# ADDENDUM NO. 5

Greenfield Central High School Auditorium Renovation and Addition – Bid Package No. 1 810 N. Broadway Greenfield, IN 46140

# ADDENDUM NO. FIVE

PROJECT: GREENFIELD CENTRAL – AUDITORIUM RENOVATION AND

FLOOR PLAN -SECOND FLOOR - UNIT L

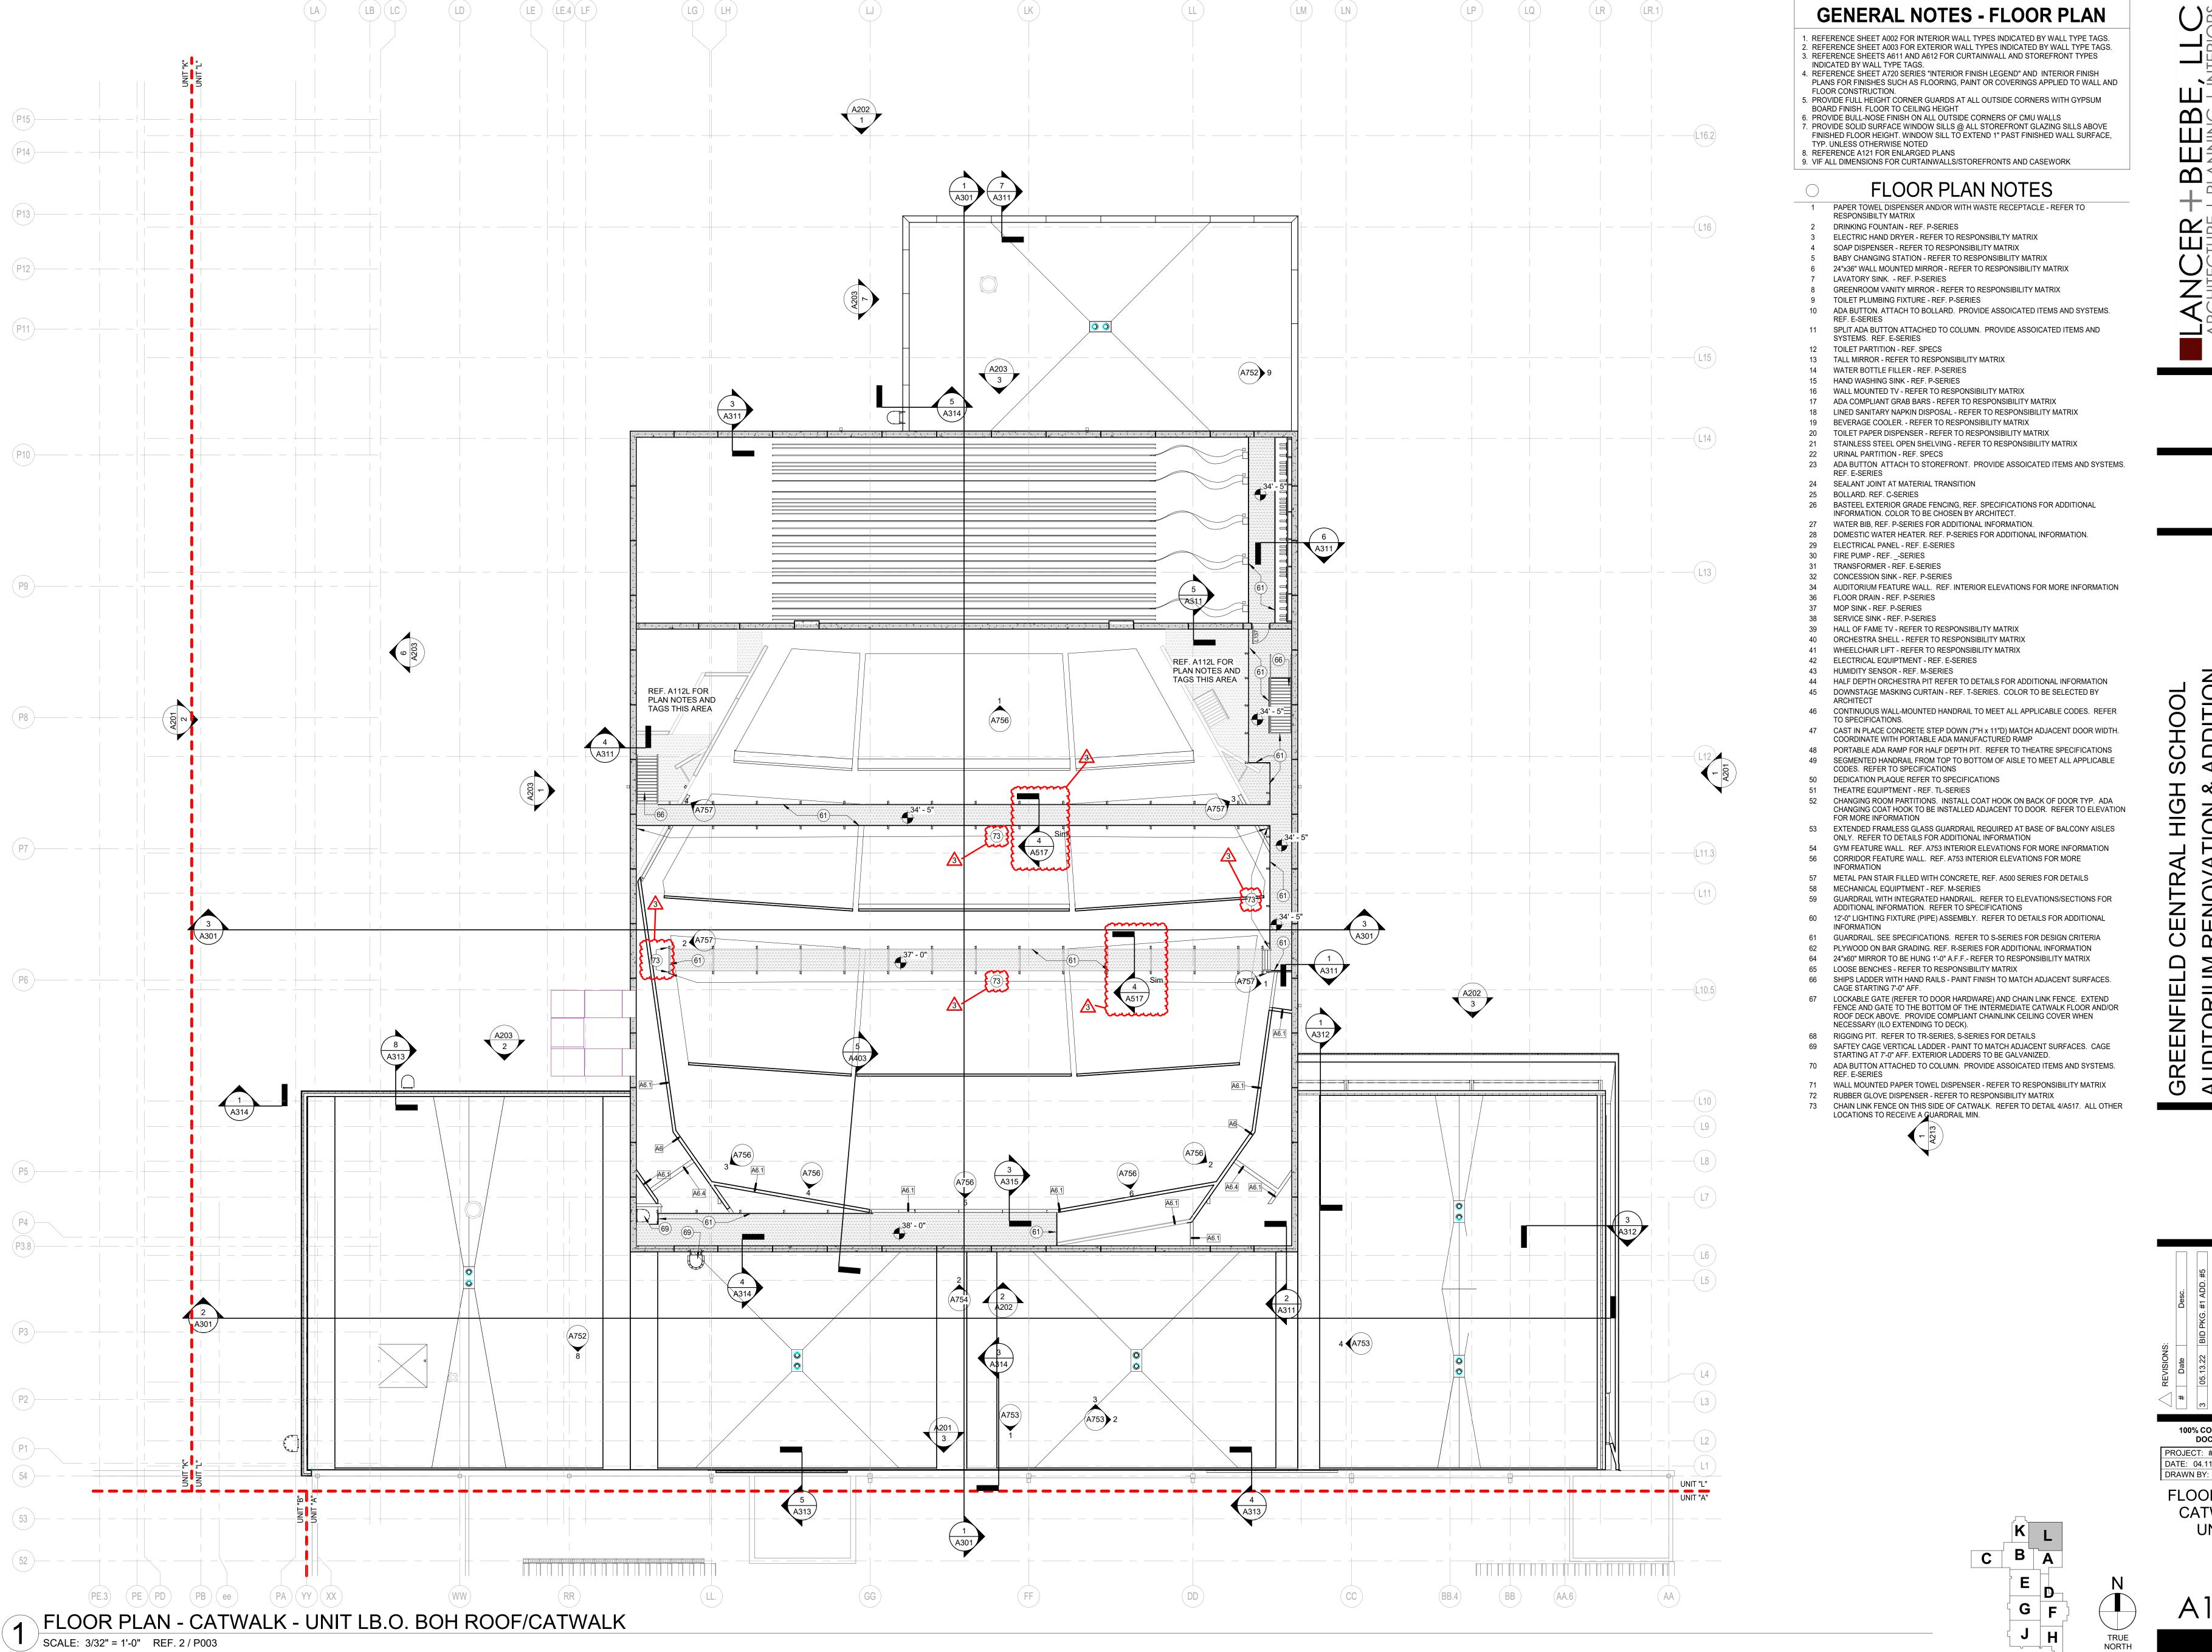
- 4. A112L FLOOR PLAN SECOND FLOOR UNIT L
  - a. RE-ISSUED ENTIRE SHEET
  - b. UPDATED PLAN NOTES
- 5. A113L FLOOR PLAN CATWALK UNIT L
  - a. RE-ISSUED ENTIRE SHEET
  - b. ADDED AND MODIFIED NOTES FOR CATWALKS.
- 6. A142 CANOPY DETAILS
  - a. RE-ISSUED ENTIRE SHEET
- 7. A201 EXTERIOR ELEVATIONS
  - a. REVISED ELEVATIONS AND ADDED NOTE 31 FOR PRECAST REVEALS.
- 8. A202 EXTERIOR ELEVATIONS
  - a. REVISED ELEVATIONS AND ADDED NOTE 31 FOR PRECAST REVEALS.
- 9. A203 EXTERIOR ELEVATIONS
  - a. REVISED ELEVATIONS AND ADDED NOTE 31 FOR PRECAST REVEALS.
- 10. A511 SECTION DETAILS
  - a. RE-ISSUED ENTIRE SHEET
- 11. A512 SECTION DETAILS
  - a. RE-ISSUED ENTIRE SHEET
- 12. A513 SECTION DETAILS
  - a. RE-ISSUED ENTIRE SHEET
- 13. A514 SECTION DETAILS
  - a. RE-ISSUED ENTIRE SHEET
- 14. A515 SECITON DETAILS
  - a. RE-ISSUED ENTIRE SHEET
- 15. A516 SECTION DETAILS
  - a. RE-ISSUED ENTIRE SHEET
